# Accessibility Survey

## City of Downey Quinn Street - Bellman Avenue to Cul-De-Sac

Date of Inspection  
7/26/2017

Prepared By  
**Disability Access Consultants**  
(800) 743-7067

#### Change in Level East of Cul-De-Sac @ 33.945571700714, -118.126303553581

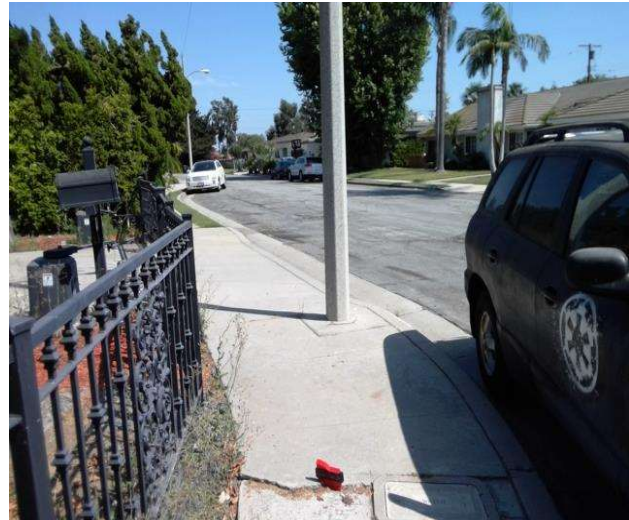
There is a change in elevation greater than recommended value.

**On-Site Finding** 0.87 inches

Ensure that the change in elevation is within the recommended value.

Recommendation Up to 0.25 inches

**Tree East of Cul-De-Sac @ 33.945522749031, -118.126196265221**

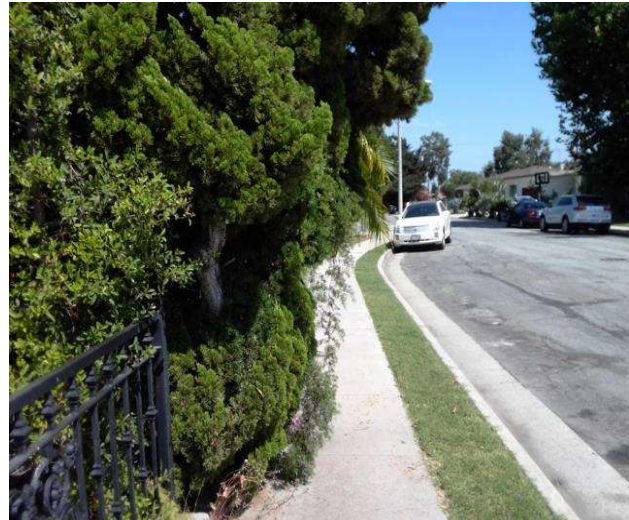
Sidewalk width at the obstruction is not compliant.

**On-Site Finding** 26.00 inches

Sidewalk width at the obstruction shall have the recommended value.

Recommendation At least 48.00 inches

**Sidewalk West of Brookshire Avenue @ 33.945048806281, -118.125388920307**

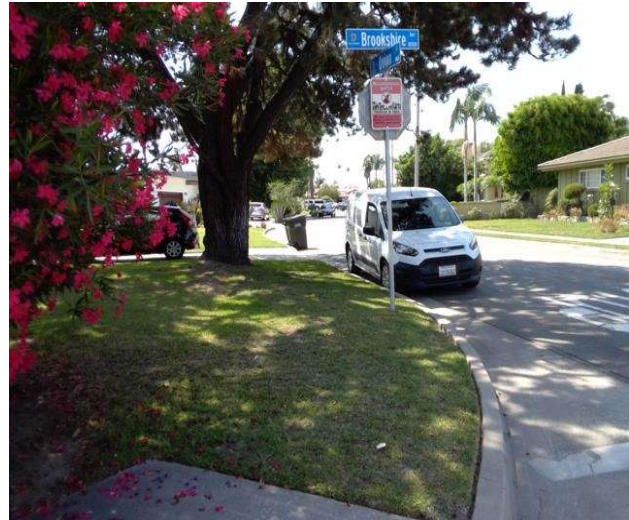
Section of sidewalk is missing and consists of dirt, grass or gravel.

**On-Site Finding** 200.00 feet

Provide a compliant sidewalk for the missing section.

**South Side @ 33.945031005563, -118.125375509262**

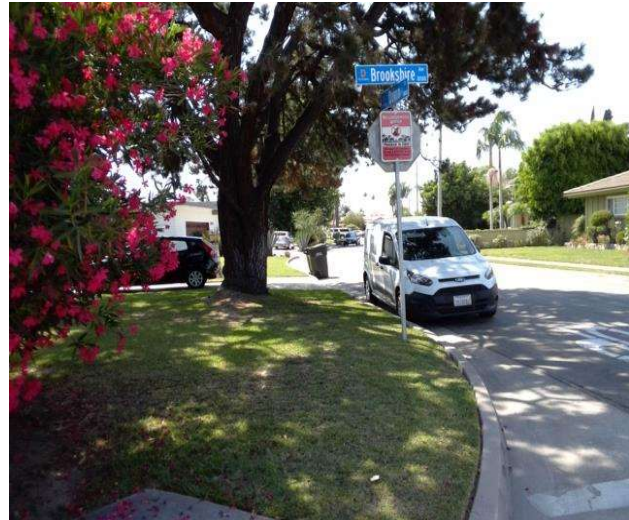
There is no 60X60 turn area at every 200 feet.

**On-Site Finding** Not Found

Provide a 60X60 turn every 200 feet on the sidewalk.

**Change In Level East Of Pangborn Avenue @ 33.936717663454, -118.108389079571**

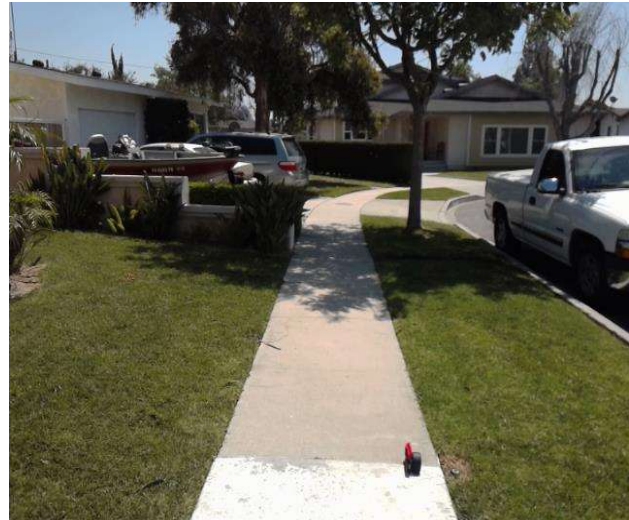
There is a change in elevation greater than recommended value.

**On-Site Finding** 0.50 inches

Ensure that the change in elevation is within the recommended value.

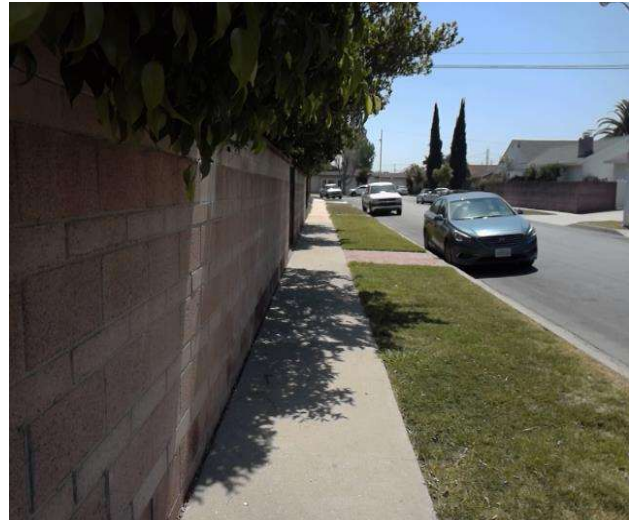
Sidewalk cross slope is not compliant.

**On-Site Finding** 3.80 percent for 20.00 feet

Repave the sidewalk surface with the recommended cross slope.

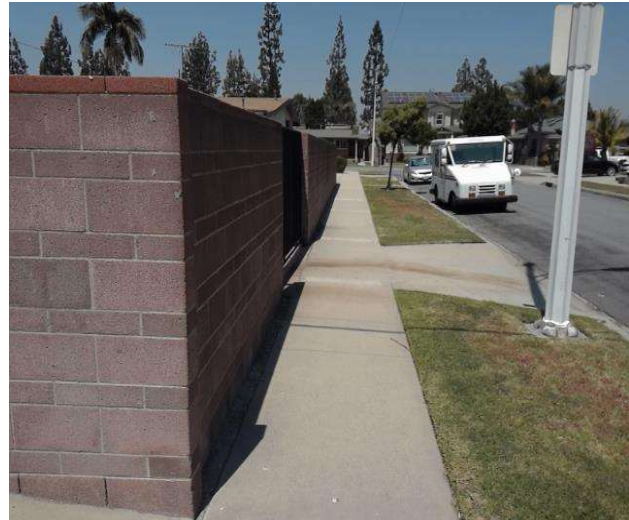
Sidewalk cross slope is not compliant.

**On-Site Finding** 4.20 percent for 10.00 feet

Repave the sidewalk surface with the recommended cross slope.
